**Tri-C Westshore Campus
The Pantry
C20229009
GC BID PACKAGE
Addendum No. 01**

Pre-Bid Meeting Minutes

Re: **THE PANTRY, TRI-C CONNECT**
WESTSHORE CAMPUS
CUYAHOGA COMMUNITY COLLEGE
Tri-C Project No. C20229009 / BC 21-59

FIRST FLOOR PLAN - AREA 'B'

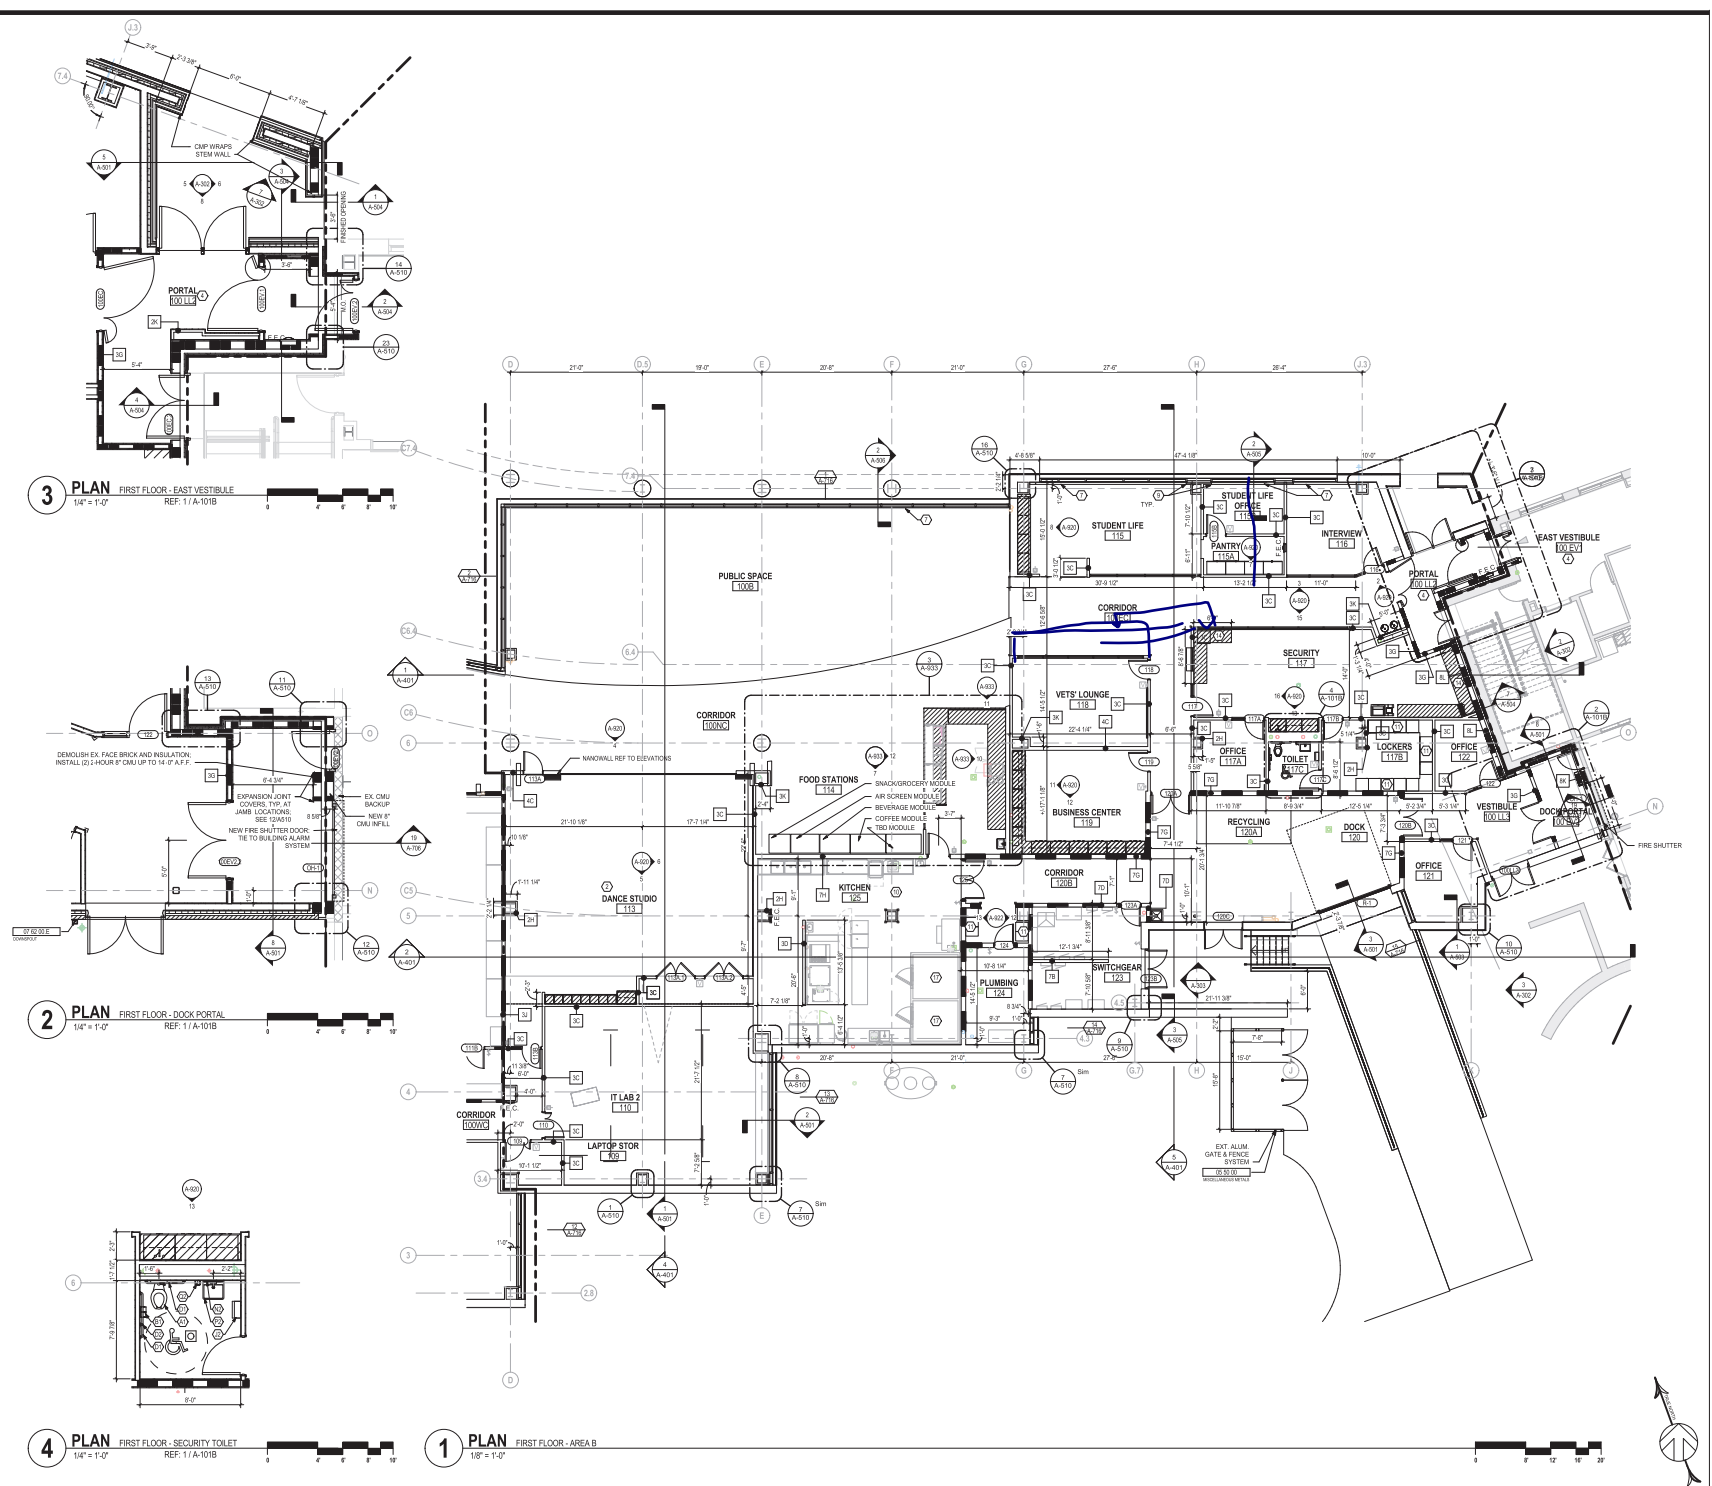
Q: Location of Electrical Panels?

Q: Fire Alarm system provider, location of panel?

A: Switchgear #123, see attached plan A-101B (Arch set 1)

A: Bay Mechanical, Contact: Chuck Hall, CHall@baymec.com, location to be confirmed:
Switchgear #123, see attached plan A-101
